TMC SPECIFICATION NO. S - 395

TITLE: RSC-2 to RSC-3 MODIFICATION KIT

APPROVED *PLK. JDR* MODIFICATION KIT, TMC NO. 143

To describe the procedure for modifying the RSC-2 to become an RSC-3.

FIGURE 1

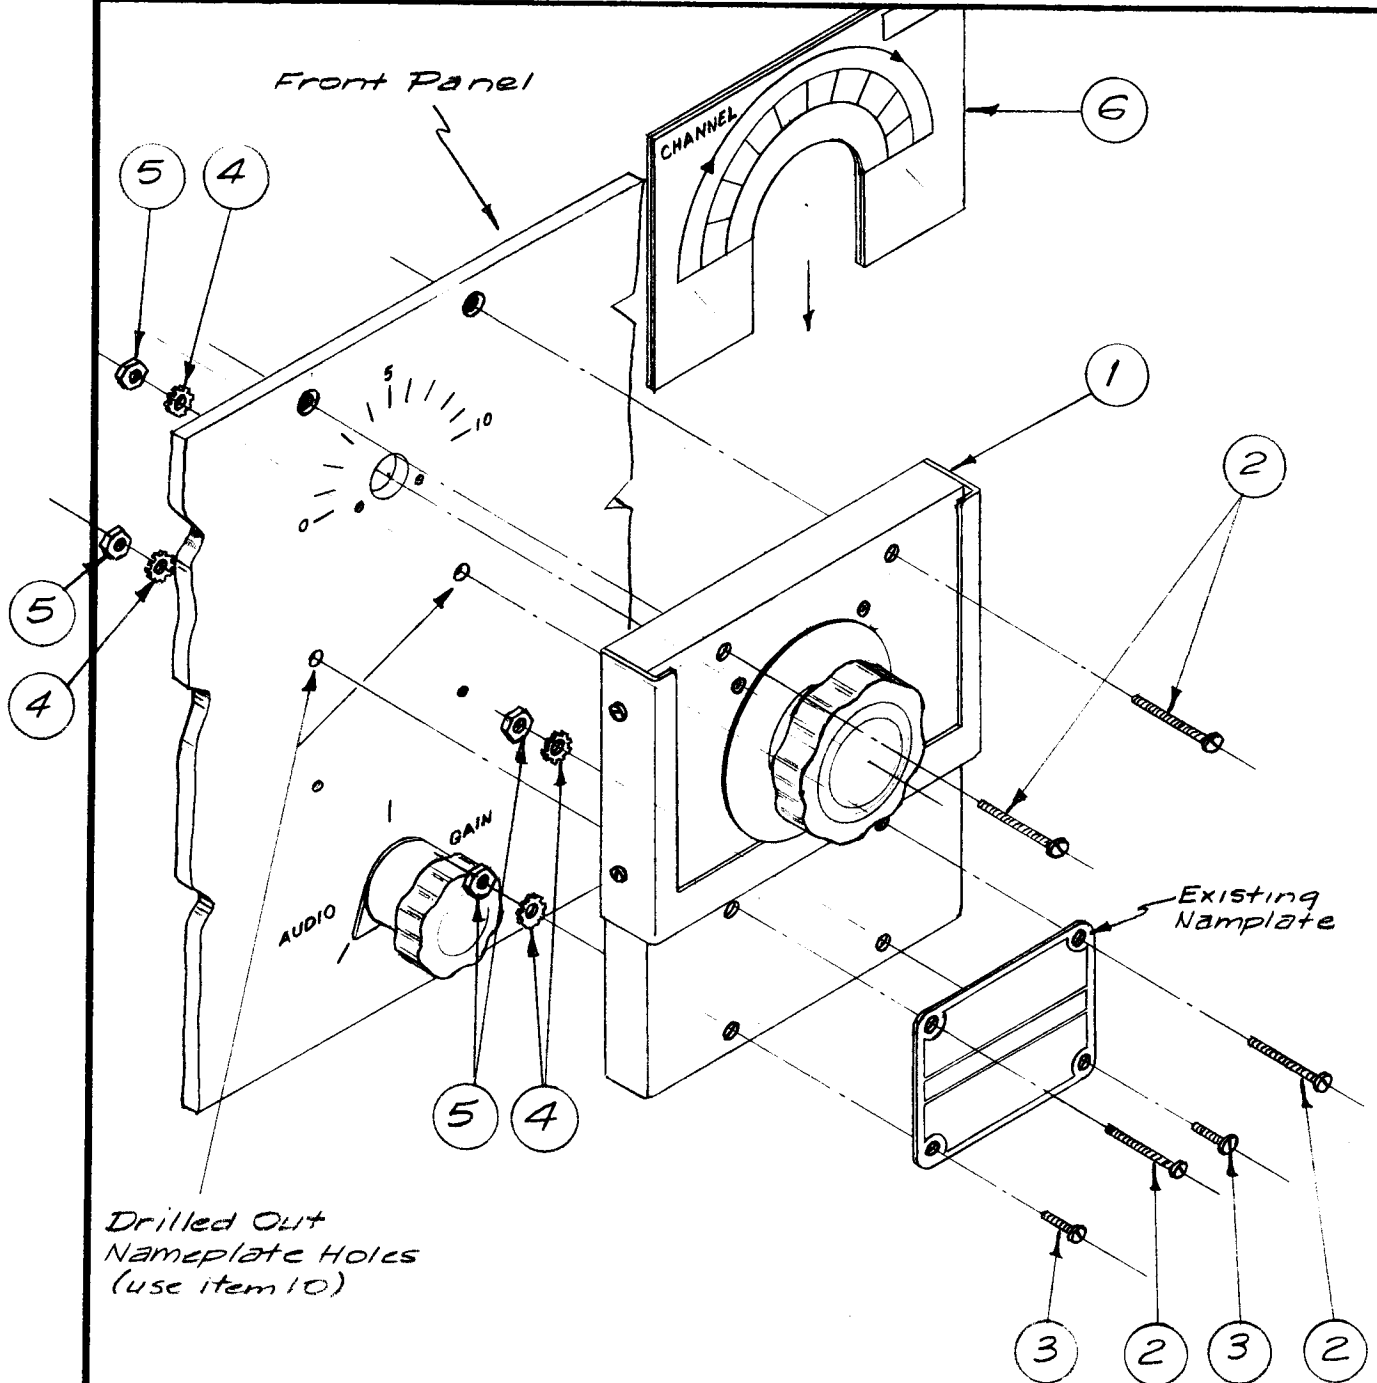
1. Changing the Front Panel arrangement to accommodate a new Main Tuning Dial Assembly, A-1590.
2. Replacing the existing loudspeaker, LS-102, with a new improved loudspeaker, LS-104.

16. One each CA-401-96-6-6.5, Cable, Insulated, #22, White/Blue, 6-1/2" long, marked with #6.
2. Remove Nameplate from Front Panel of RSC-2.
 3. Assemble Nameplate to Main Tuning Dial Panel with two 3-48 X 1/4" long screws (item 3), two lockwashers (item 4), and two nuts (item 5), using the two bottom holes as shown in Figure 1.

6. Remove the Channel card holder from top of Front Panel. (Above R.F. Gain.)
7. Mounting of the Main Tuning Dial Assembly in Place of the R.F. Gain Control (See Figure 1)

- a. Place the Dial Assembly (item 1) on Front Panel as shown in Figure 1 and insert Dial Assembly shaft into the insulated coupling. (Do not tighten Set Screws).

- b. Insert two 3-48 X 7/8" long screws (item 2) into the two top holes of the Dial Assembly and screw them into the two card holder tapped holes on the Front Panel.

- c. Insert two 3-48 X 7/8" (item 2) into the two top holes in the Nameplate on the Dial Assembly and pass them through the new 7/64" diameter drilled holes in the Front Panel. Fasten on rear of Panel with two #3 Lockwashers (item 4), and two 3-48 nuts (item 5).

- g. Insert the two Tuning Dials (item 6) into slot as shown in Figure 1.

FIGURE 2

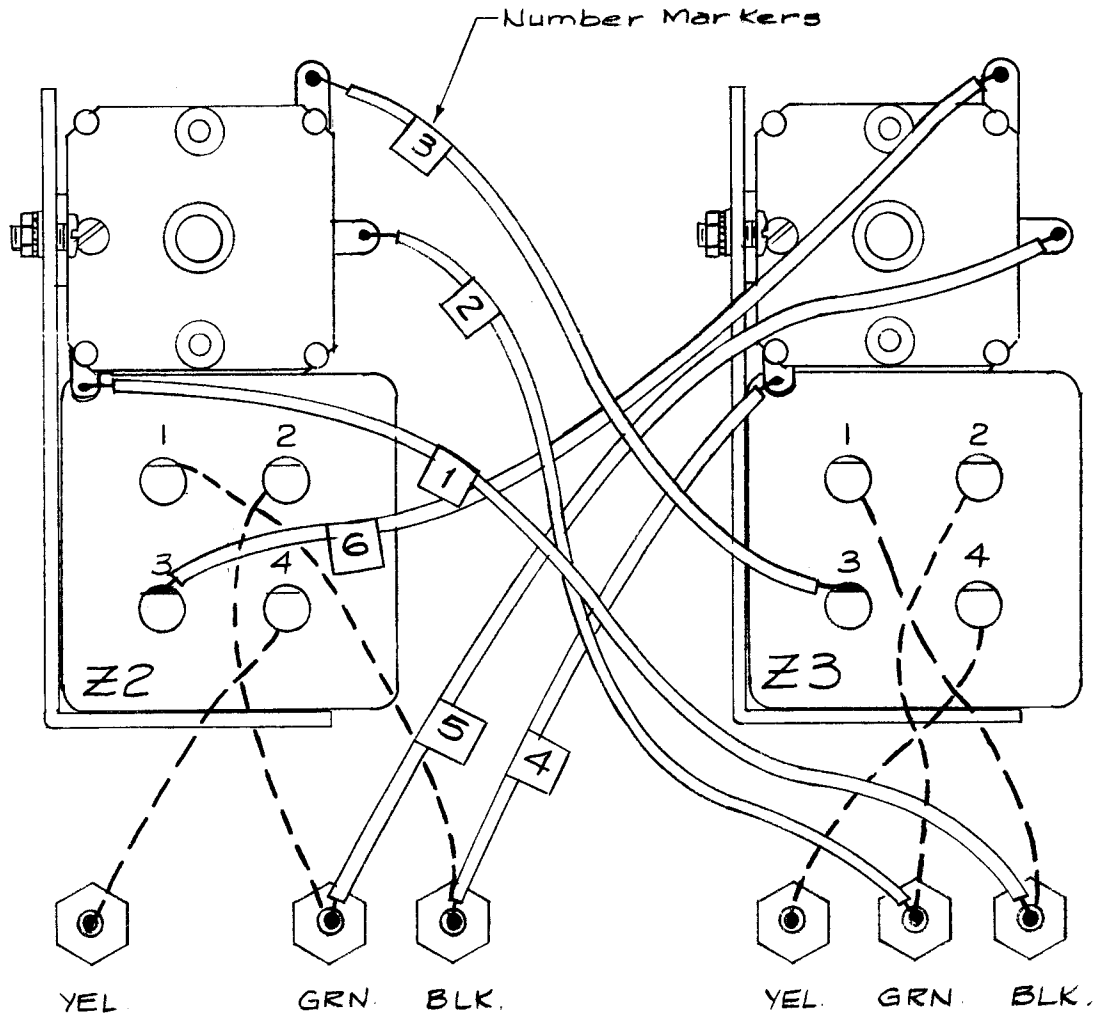
10. Rewiring Control Circuits.

- a. Referring to the New Controls, R.F. Gain and Main Tuning, remove the three leads from the variable condensers. Remove the other ends of the leads from the terminals on 22 and 23.
- b. Substitute the six new leads, numbered 1 to 6 (items 11 to 16) for those removed, which then cross connect the "2" Ass m-7 bles to the proper variable condensers. Connect the leads as shown in Figure 2.
- c. Check Frequency of Oscillator according to Instruction Manual, Corrective Equipment Maintenance, Model RSC, Section 1C, Page 4-11.

Note: Dotted Lines Indicate Existing Wires in Unit which Will not be changed.

FIGURE 3

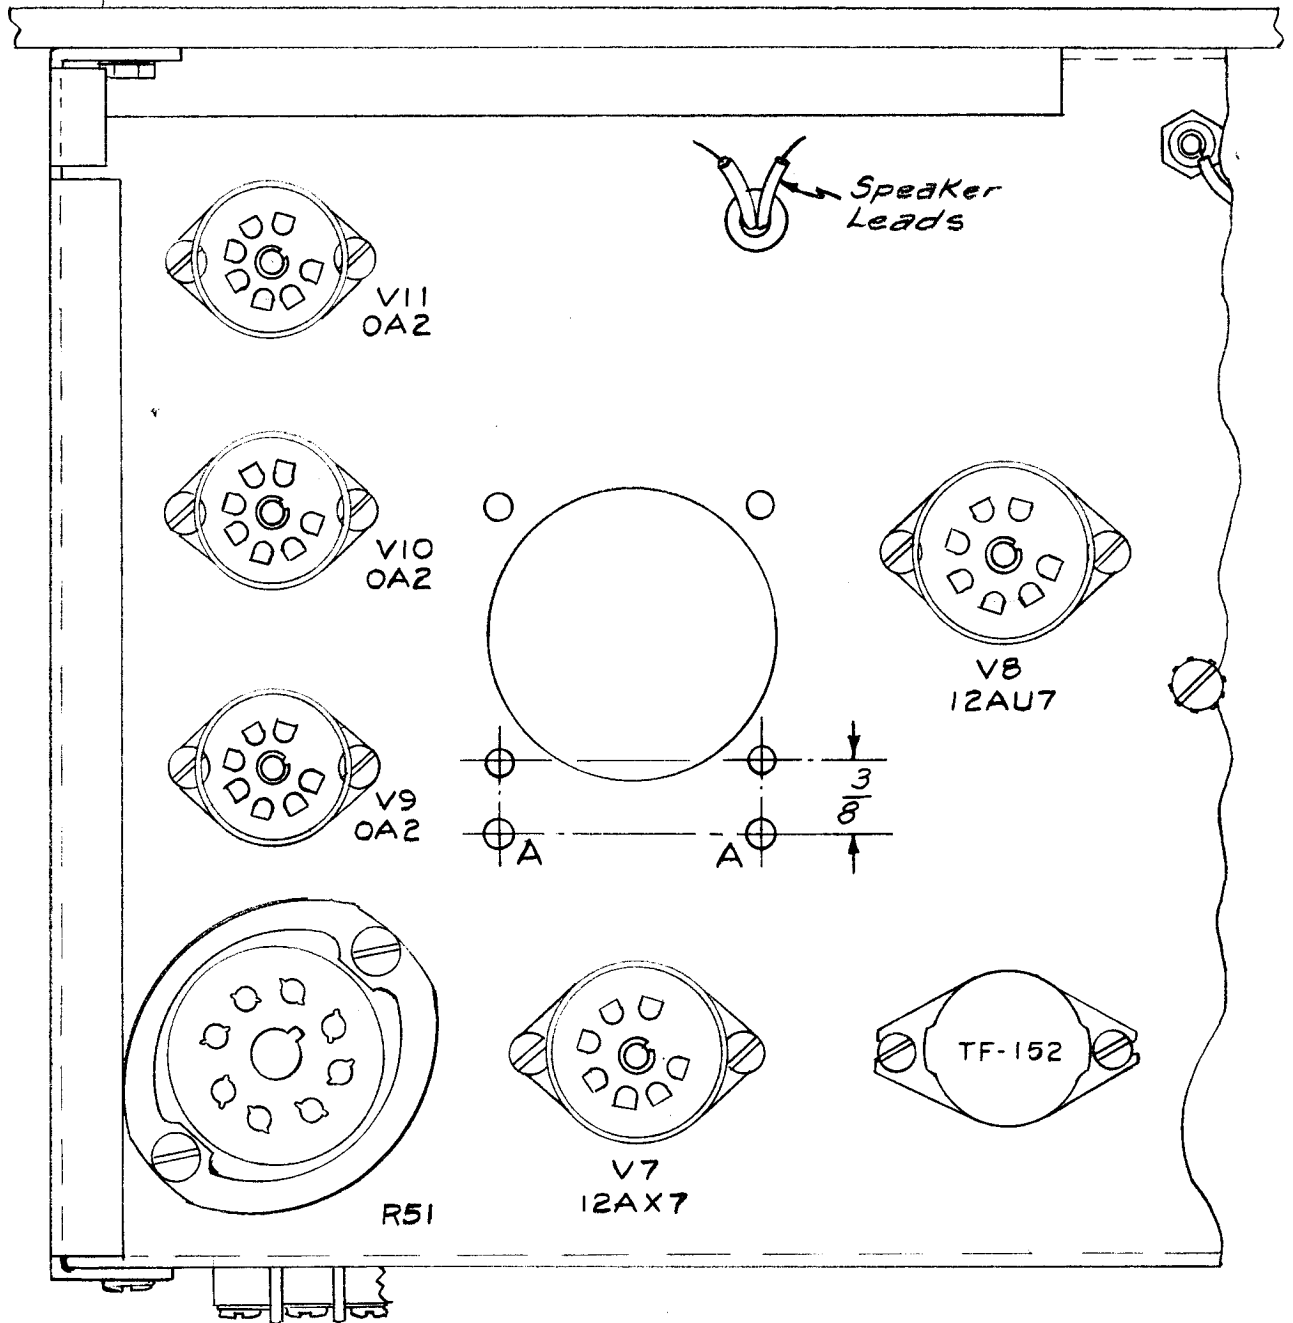
13. Locate two "A" holes as shown in Figure 3. Drill out with 5/32" drill (item 4), being careful not to damag any leads on the underside of chassis.

LOCATE AND DRILL OUT TWO "A" HOLES WITH 5/32 DRILL AS PER STEP 12.

FIGURE 4

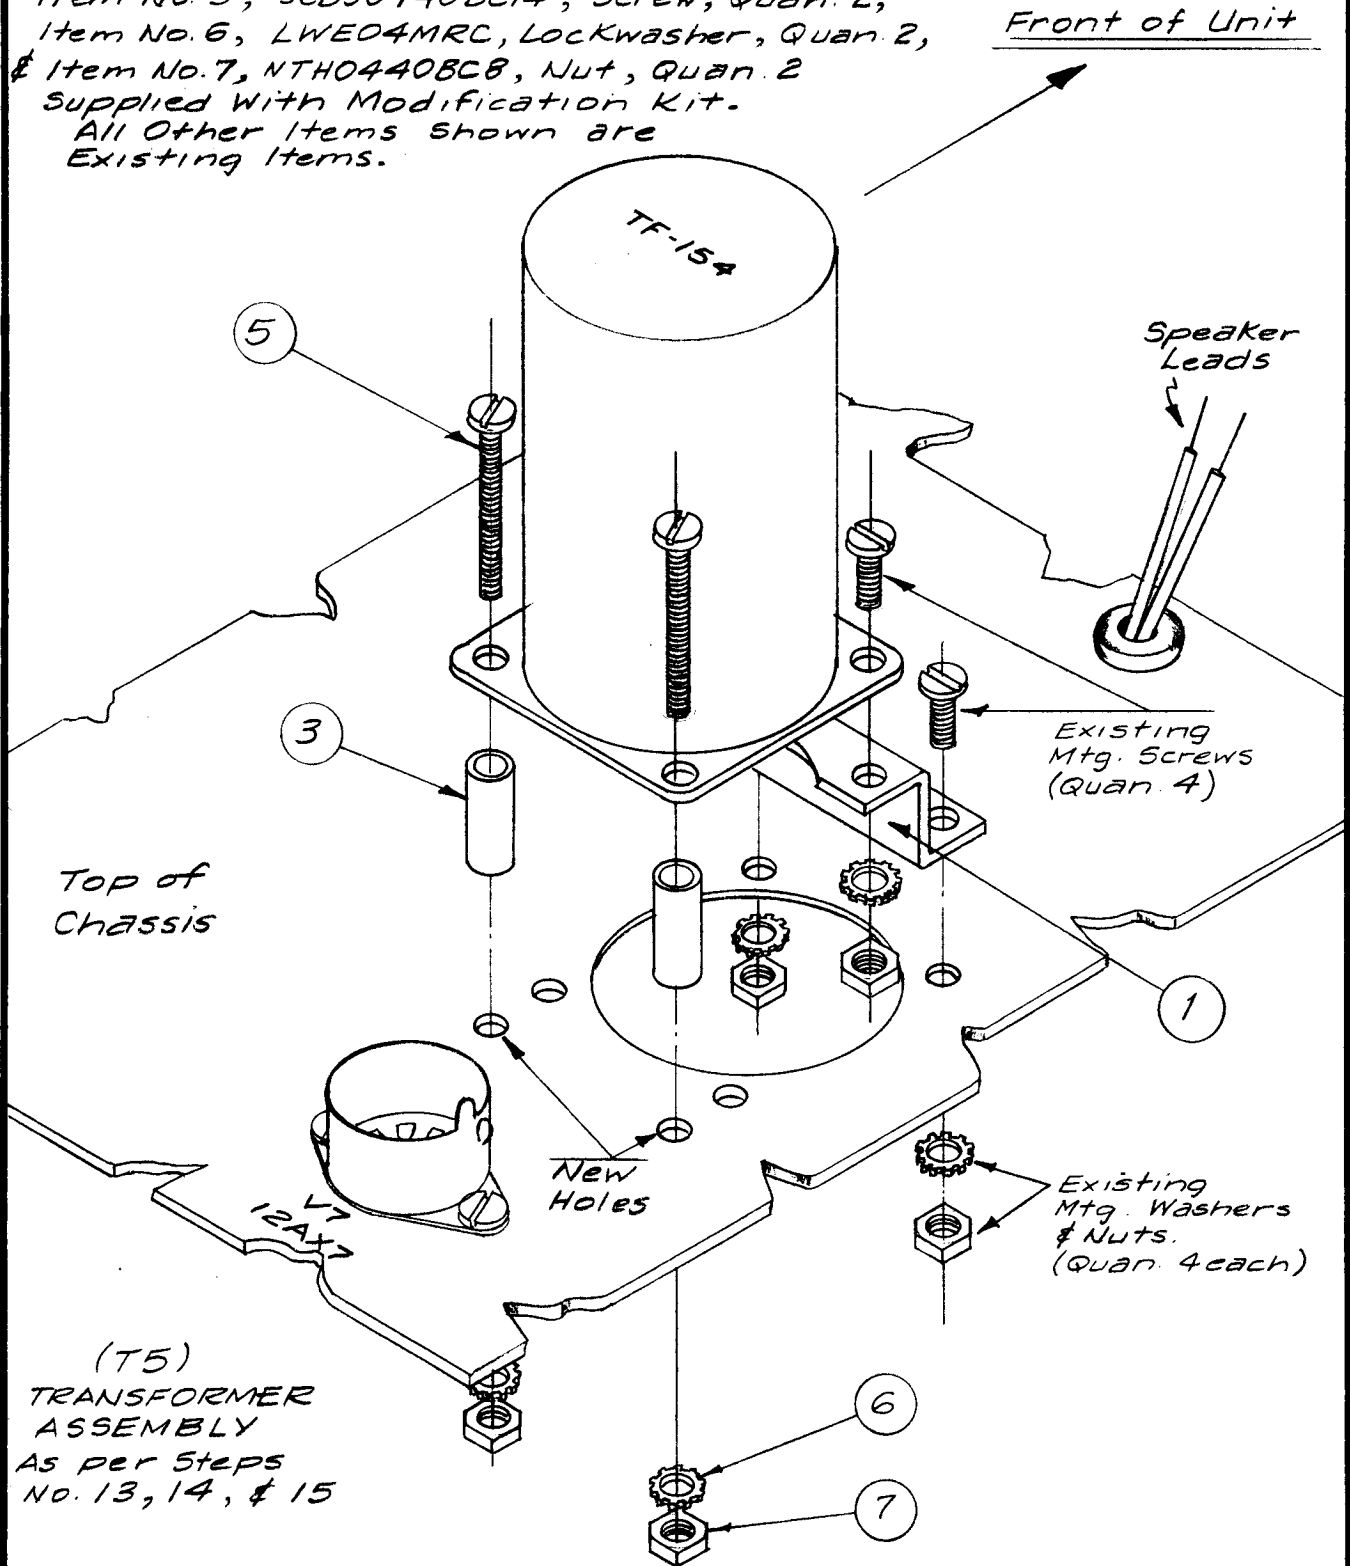
14. Mount bracket, MS-1388 (item 1) on Transformer, T5, as shown in Figure 4, using two of the existing original 4-40 mounting screws, nuts, and lockwashers.

15. Mount the bracket and transformer Assembly on the chassis as shown in Figure 4, using the other two original 4-40 mounting screws, nuts and lockwashers.

NOTE:
Item No. 1, MS-138B, Bracket, Quan. 1,
Item No. 3, TE-117-31, Spacer, Quan. 2,
Item No. 5, SCBS0440BC14, Screw, Quan. 2,
Item No. 6, LWED4MRC, Lockwasher, Quan. 2,
& Item No. 7, NTH0440BCB, Nut, Quan. 2
Supplied With Modification Kit.
All Other Items Shown are
Existing Items.
